MEMORANDUM

CITY OF WATERTOWN, NEW YORK
PLANNING AND COMMUNITY DEVELOPMENT DEPARTMENT
245 WASHINGTON STREET, ROOM 305, WATERTOWN, NY 13601
PHONE: 315-785-7741 – FAX: 315-782-9014

SUBJECT: Sketch Plan Approval – 312 Gotham Street

Request: Sketch Plan Approval to construct a two-story 1,113 SF gross floor area building addition at **312 Gotham Street**, Parcel Number 11-02-224.000

BACK ELEVATION

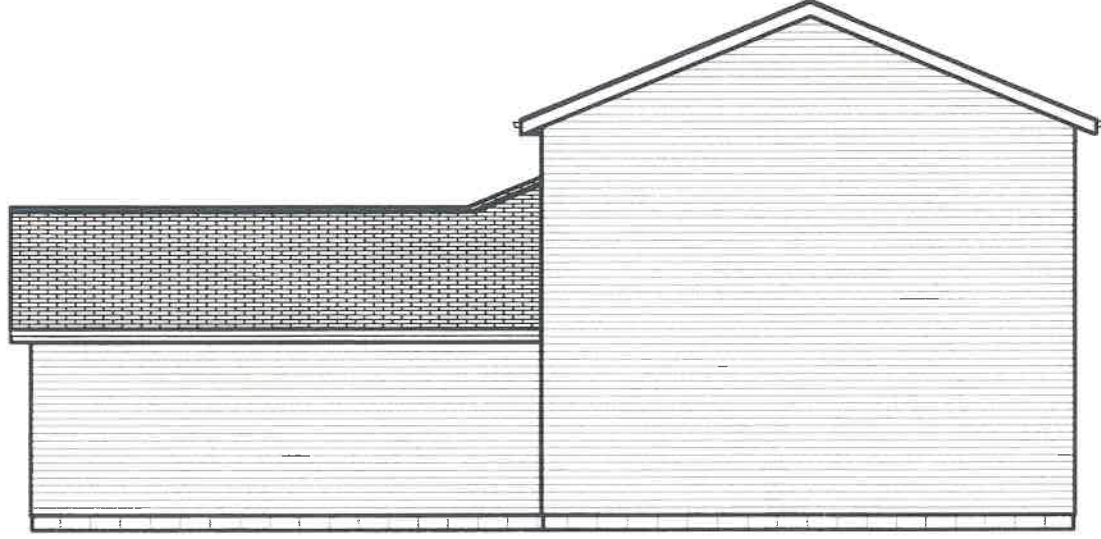
The drawings depict an orientation for the proposed garage with one garage door on the west (rear) façade and one on the south (side) façade, meaning that under the depicted orientation, the two vehicles parking in the proposed garage would enter via perpendicular entrances. This would create a situation where only an extremely compact car could use the south entrance, lest the two vehicles come into conflict with one another. The applicant shall be prepared to discuss the rationale for this orientation.

It merits consideration that while one of the current tenants might own a compact car today, the design should reflect the fact that both the owner and the tenants of this property may change in the future and have different needs than today. For this reason, Staff recommends that the applicant consider reorienting the proposed garage with both garage doors on the west (rear) façade of the building, particularly since the driveway must connect to the rear anyway and it would not involve additional paving. The applicant has communicated to Staff an openness to this change.

1. The applicant shall be prepared to discuss the rationale for the depicted orientation of the proposed garage door and should consider reorienting it with both garage doors on the west (rear) facade.
2. The applicant must fire-rate the northern exterior and eastern interior walls of the proposed addition and meet all other applicable building codes as a condition of obtaining a Building Permit.
3. The applicant must obtain a Building Permit prior to construction.

FIRST FLOOR PLAN
RESIDENTIAL ADDITION

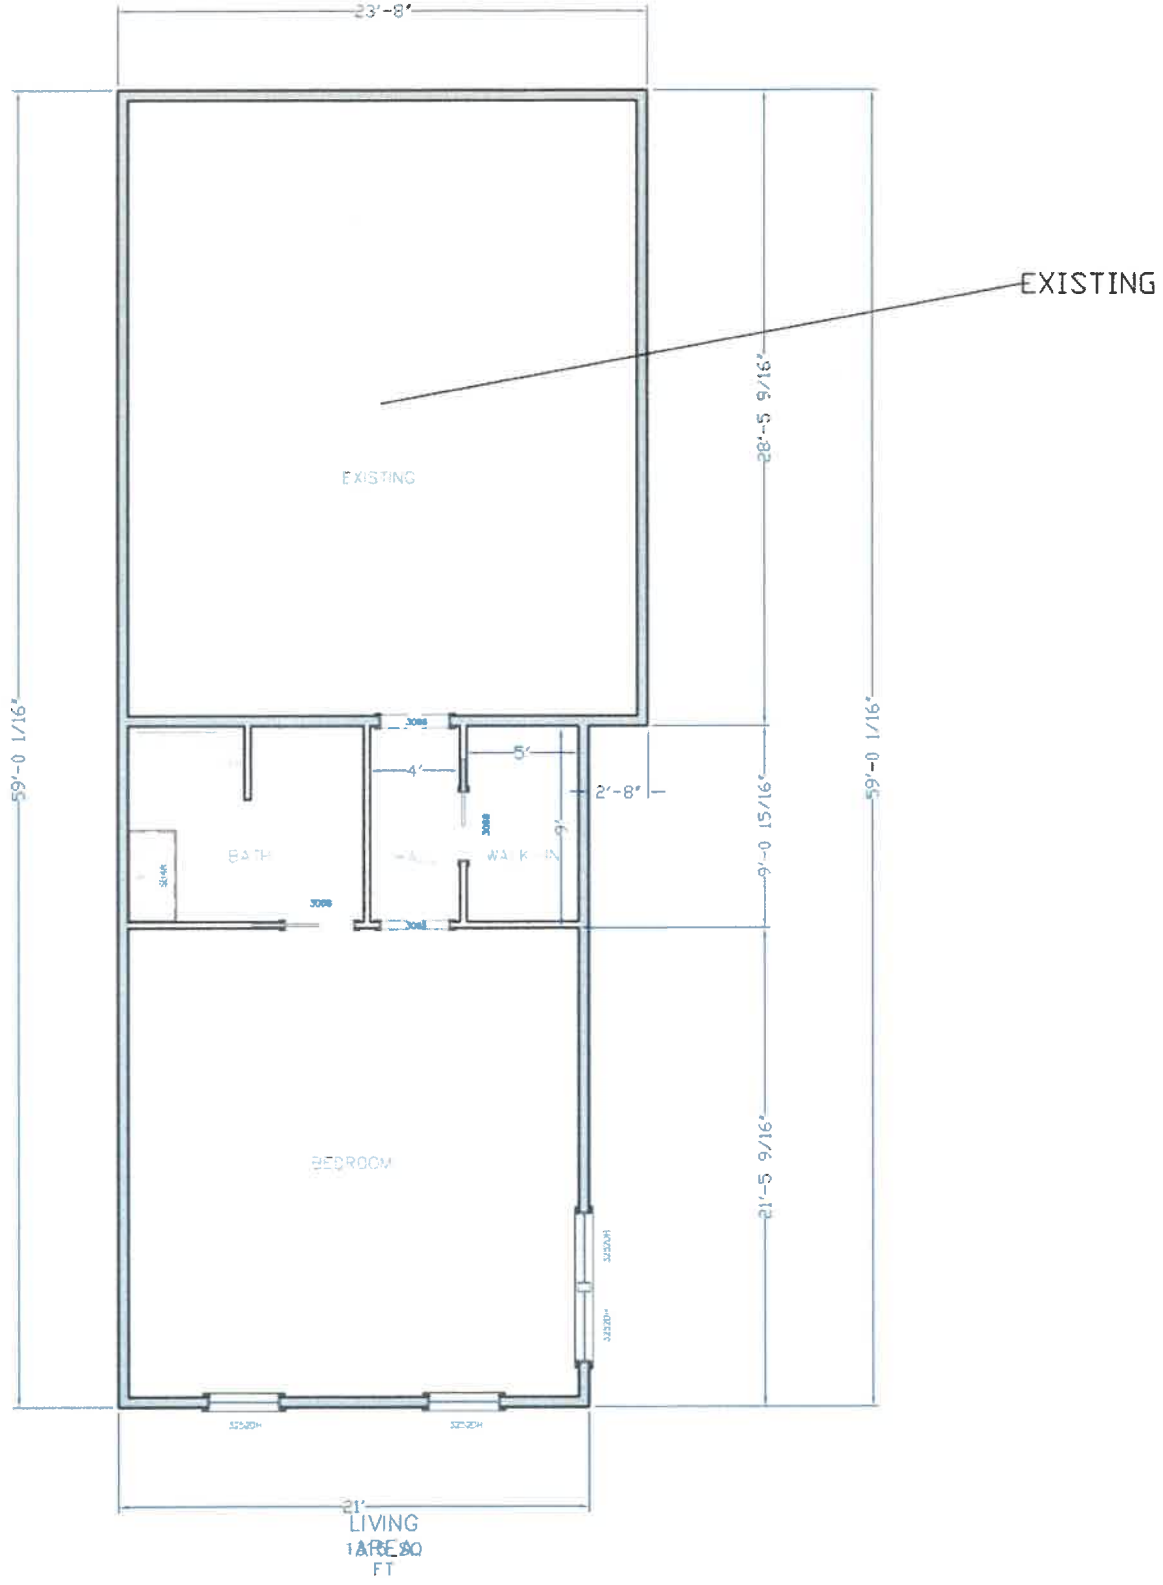
Miscellaneous: While the Zoning Ordinance does not contain any setback requirements in the Downtown District, the applicant is still responsible for meeting International Building Code. As such, since the northern face of the proposed addition would be within five (5) feet of a property line, the City’s Bureau of Code Enforcement will require the applicant to fire-rate this wall as a condition of a Building Permit. It is also necessary to fire rate the new internal wall that will connect the proposed addition to the rest of the dwelling.
